# UNITED STATES PATENT AND TRADEMARK OFFICE

**Advisory Action  
Before the Filing of an Appeal Brief**

09/474,299

**OBLON, SPIVAK, et al**  
**Docket No: 232362US28X**  
**Inventor: Marcel F. SCHEMMANN, et al.**  
**Serial No: 09/474,299**  
**Reply to OA dated: 10/18/05**  
**Replacement Sheet**

4/11

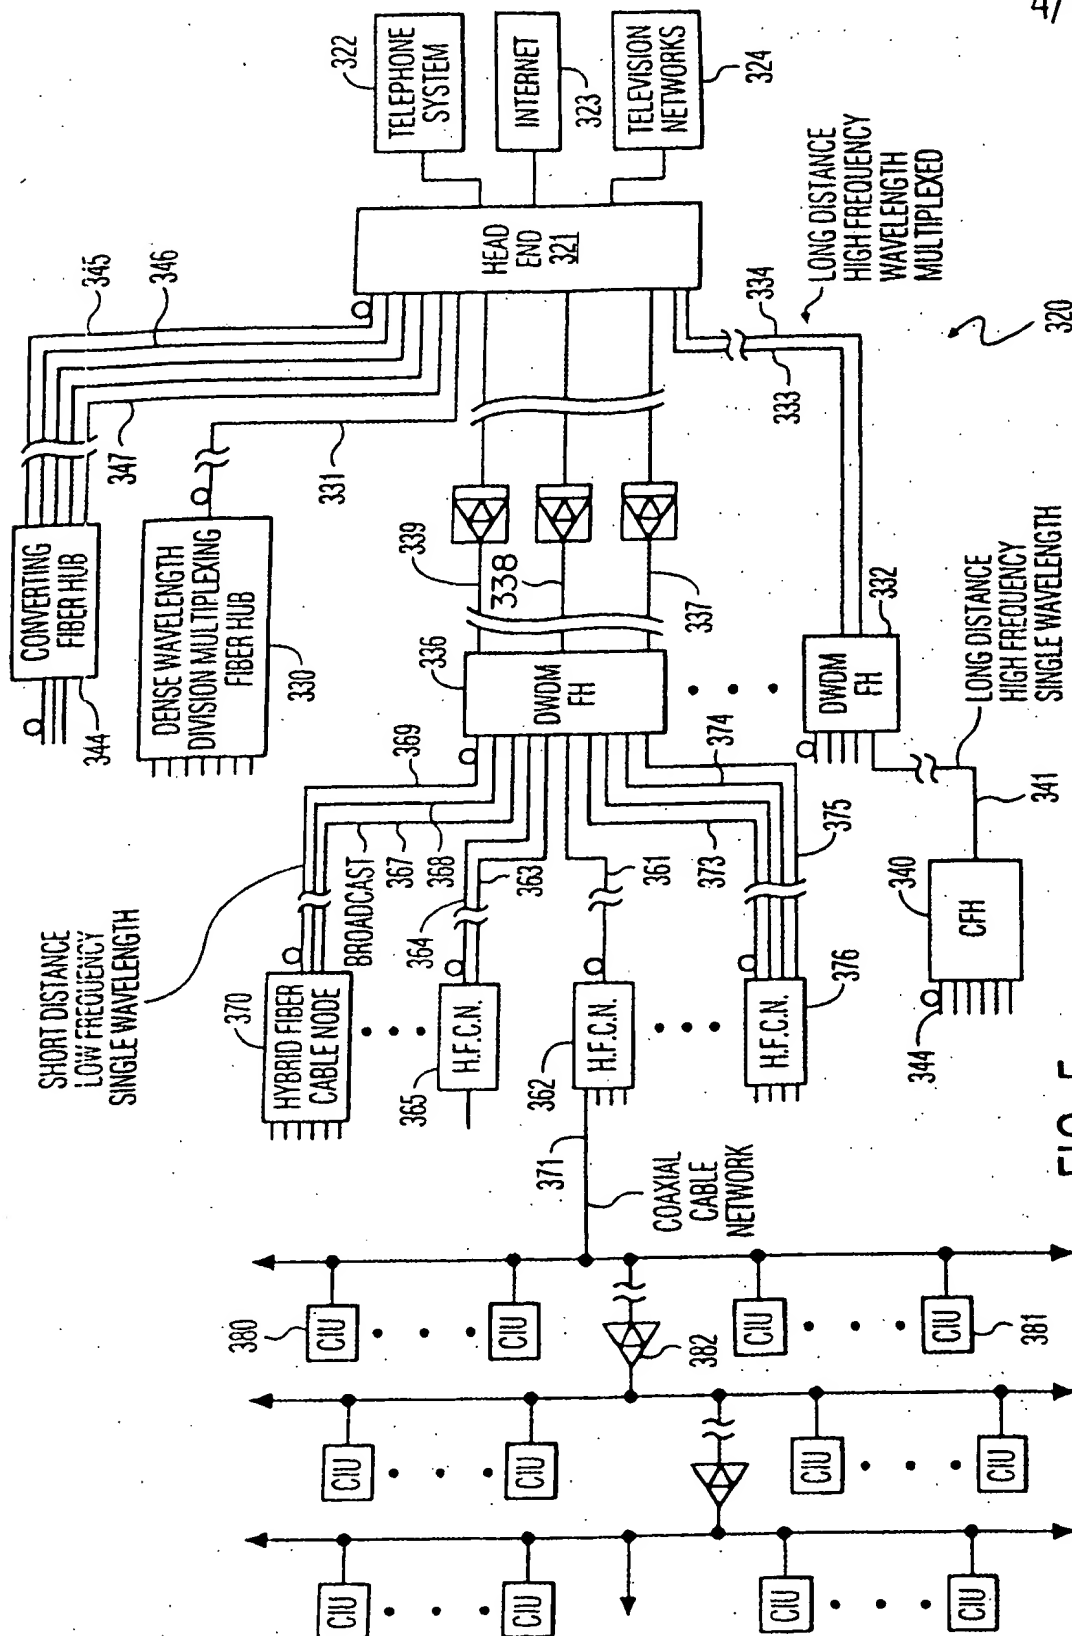
Regarding Applicant's response to the objections to the drawings in the previous Office Action (mailed on 18 October 2005), Applicant's response is noted and appreciated. Replacement drawings for Figs. 5 and 7 were filed on 18 January 2006. Although some of the previous objections are overcome by Applicant's proposed drawing amendments, newly filed Fig. 5 reintroduces issues raised in a previous Office Action (mailed on 18 November 2004). That is, newly filed Fig. 5 reintroduces reference characters 373-376, which are missing from the specification. Deletion of these characters is suggested as a suitable remedy. Also, although Applicant's newly filed Fig. 7 replaces the lead line for 554 to a location that is closer to the accurate location than the previous location, this lead line is still slightly misplaced. The bridging paragraph of p. 35-36 indicates that the lead line for 554 should be located on the path between HCM 551 and the node dot that is to the left of splitter 552. Replacing the lead line for 554 to this location is suggested as a suitable remedy. Accordingly, these newly filed Figs. 5 and 7 are disapproved.

Disapproved by DSH

FIG. 7

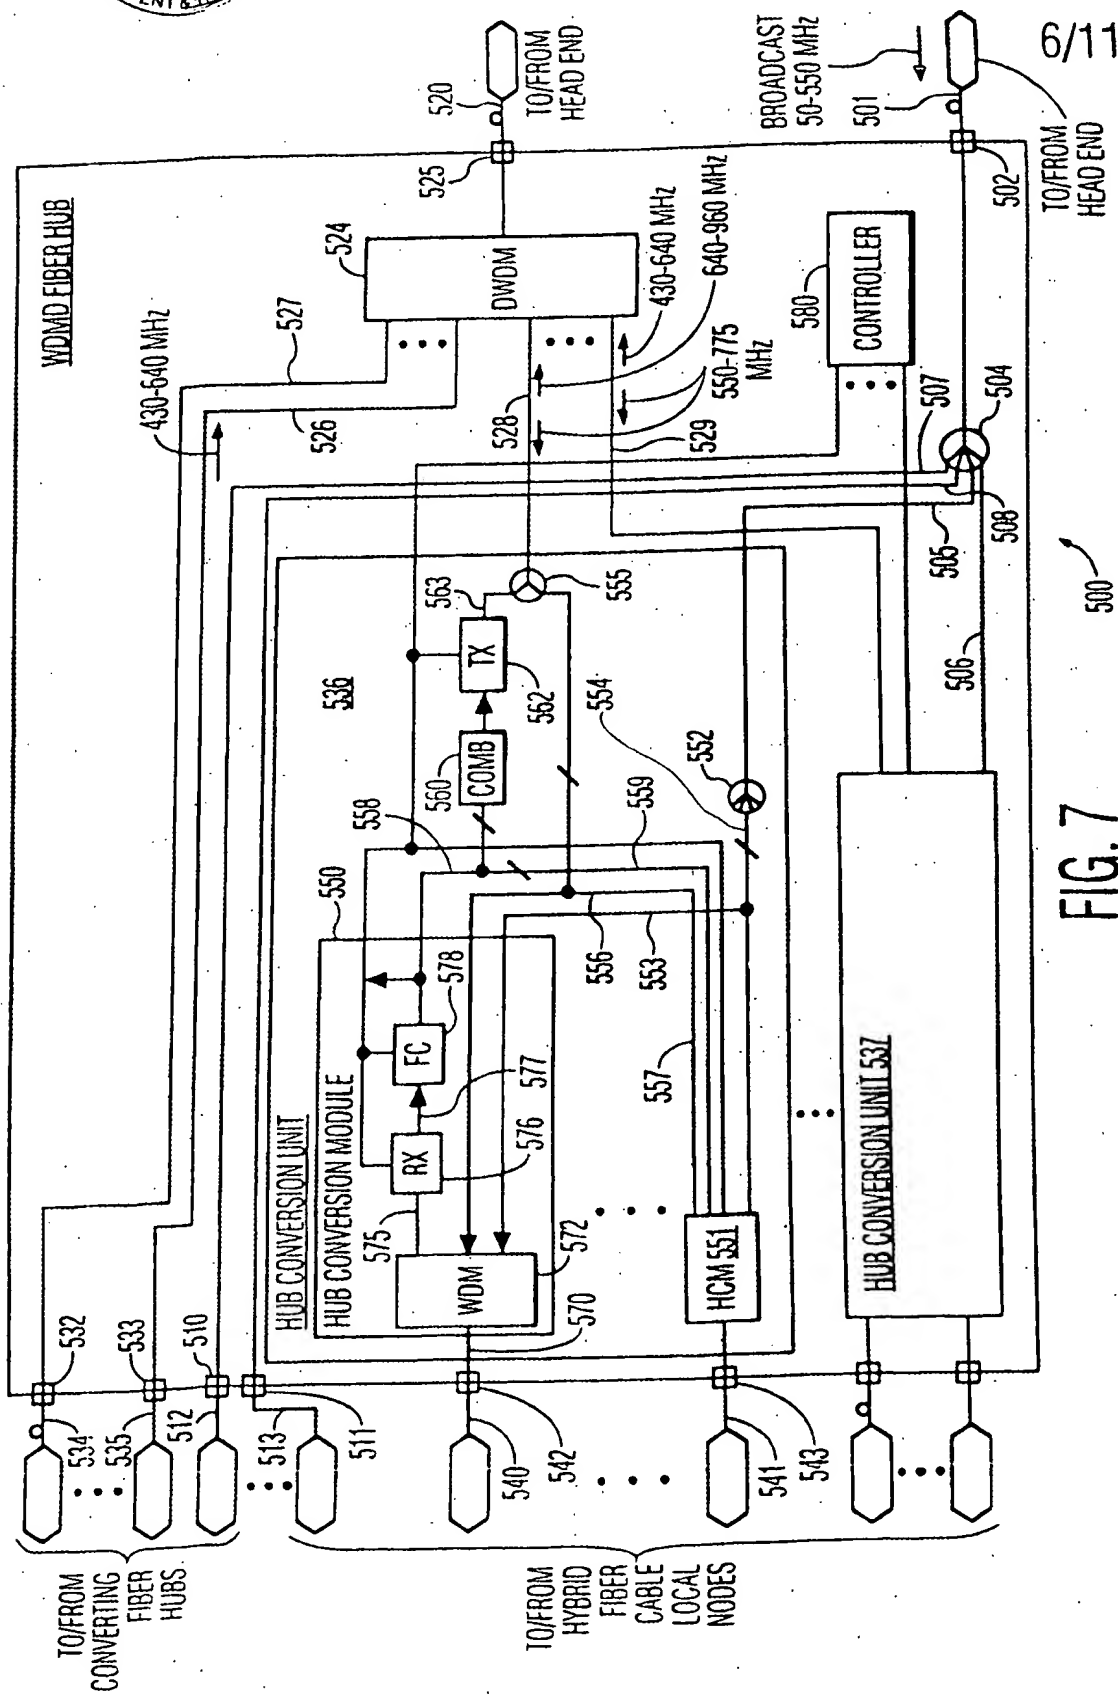
Disapproved by DSK  
25 JANUARY 2006
